With the Advisory review of the monitoring programme for the Lining of the Ismailia Canal Pilot Project, Egypt

Review findings of the progress report no. 1. Monitoring and evaluation of the effect of lining of Ismailia Canal, (July 1999)

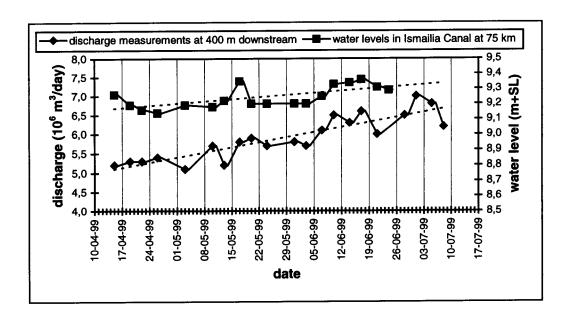
Figure 4 in Progress Report No. (1) shows variation of discharge measurements (in time) at three locations downstream of Salhia Head Regulator and Lock. This could be a result of variation of the water inflow near and upstream of the trial section due to nature (rainfall, evaporation), human action (irrigation) or artificial maintenance of discharge. Therefore, information on the water inflow (discharge) from the Salhia Head Regulator and Lock (near and upstream of the trial section) is needed. By calculating the difference between the inflow at Salhia Head Regulator and the outflow at row 3 the net loss in the trial section can be determined (as described in chapter 2; methodology). The actual seepage is depending on the circumstances during measuring, such as weather conditions.

Discharge measurements (in time) are available at tree locations and should be compared with the water levels (in time). Enclosed figure shows the discharge measurements at 400 m downstream (based on figure 4) and the water levels in the canal at 75 km (based on figure 7). No significant correlation between discharge and water level can be detected (maybe due to errors during measurements).
